Re: Renovation/Alterations  
4 Ledgewood Place  
Armonk, NY 10504  
Tax ID: 107.02-2-46

**RPRC DETERMINATION LETTER 7/3/2019 RESPONSE**  
**RPRC DETERMINATION LETTER 11/6/2019 RESPONSE**  
**STAFF REPORT-TOWN OF NORTH CASTLE 3/20/2020 RESPONSE**

Following is a point by point response to comments on the project made via the above listed memos. The comments from the RPRC Determination Letter, dated July 3, 2019 and Nov. 6, 2019 have been copied into this letter. Responses follow each RPRC comment in blue for clarity:

AVERAGE GRADE

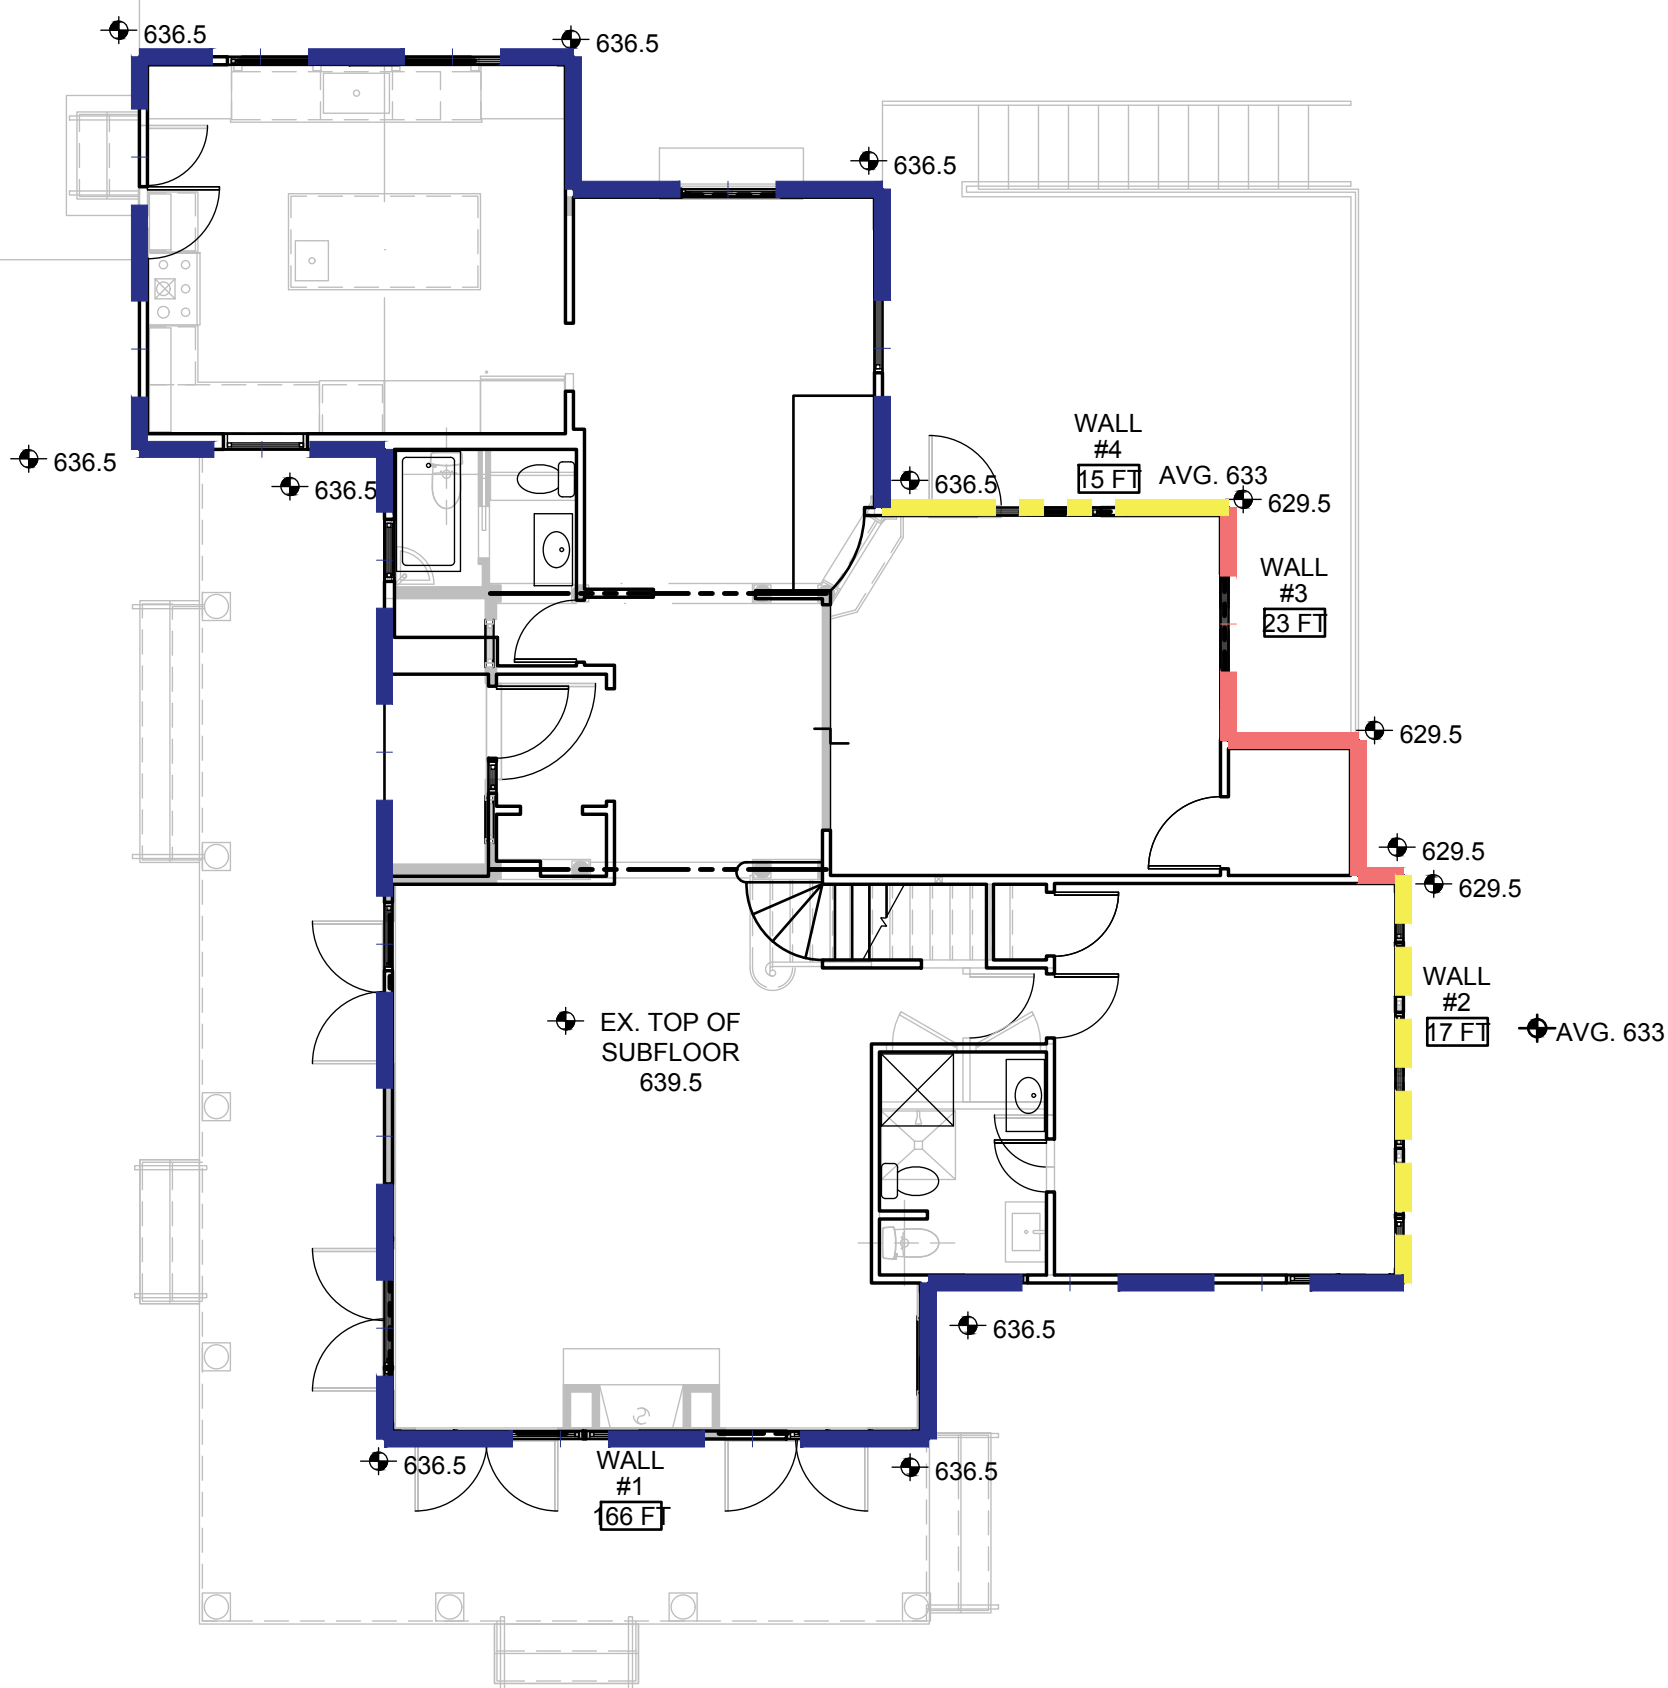
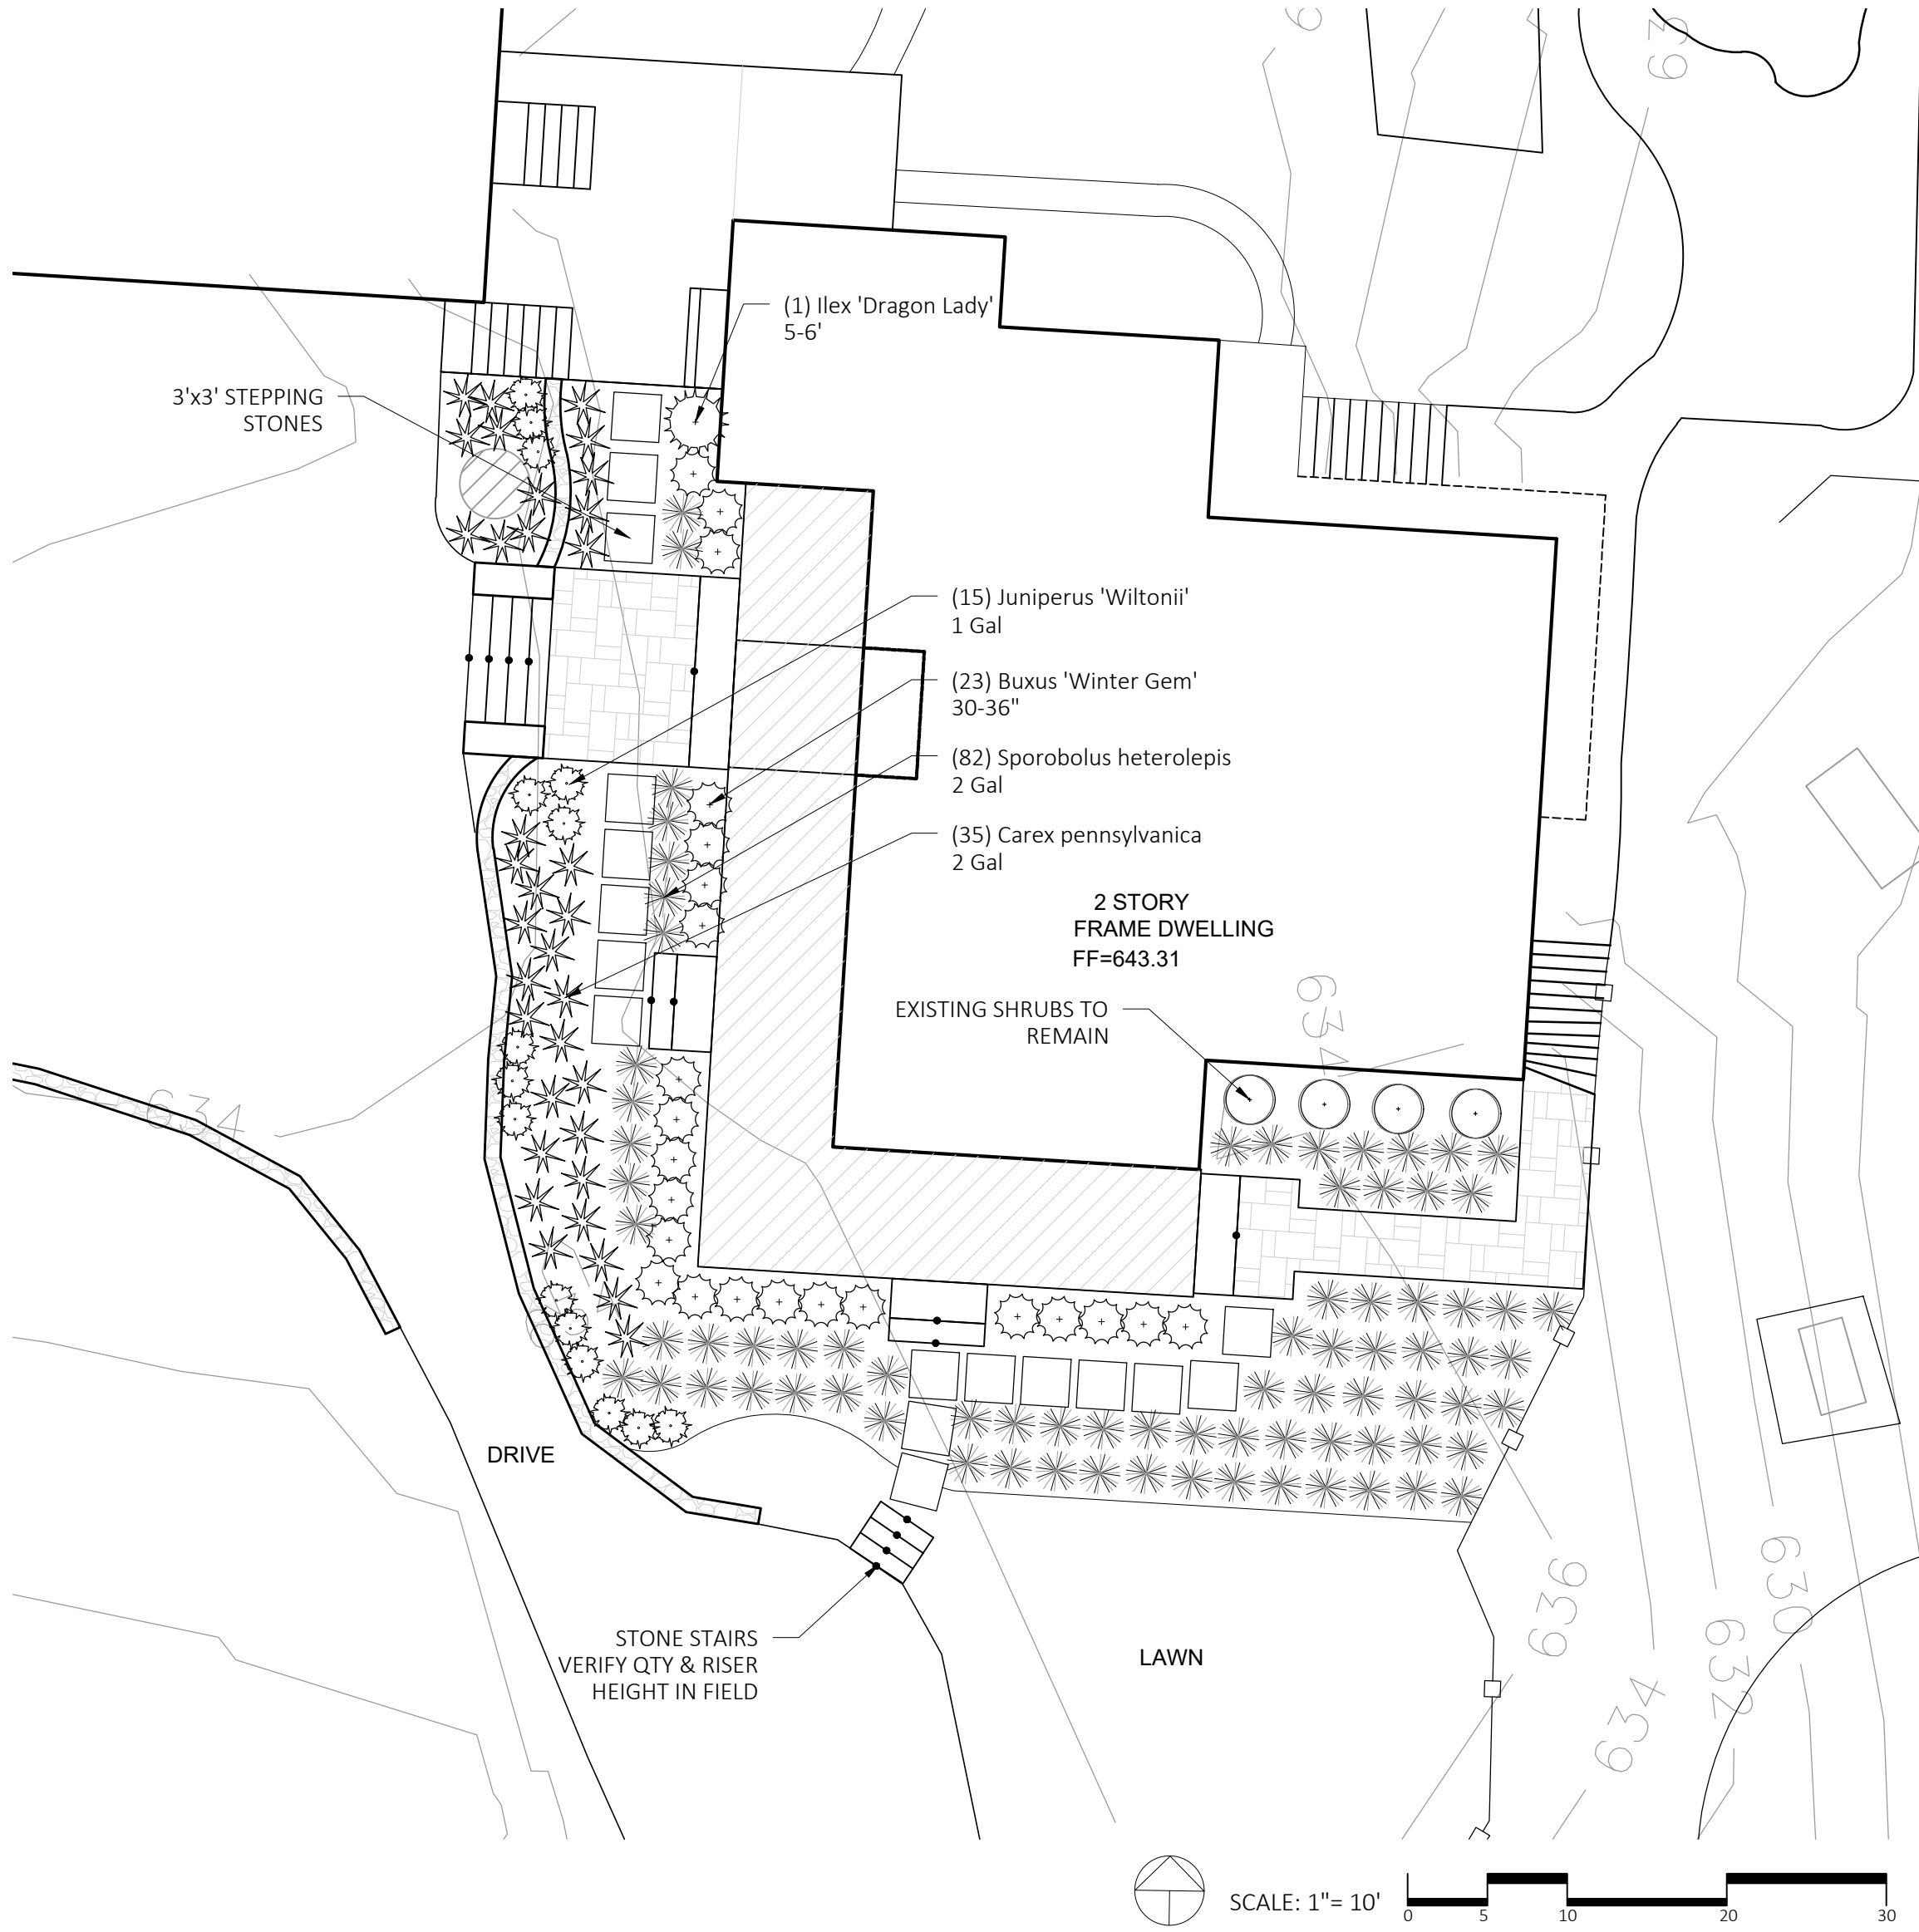
[Item #7- Building Height Exhibit is attached. See Drawing Z-101](#)

[Item #8- Maximum Exterior Wall Height Exhibit is attached. See Drawing Z-101](#)
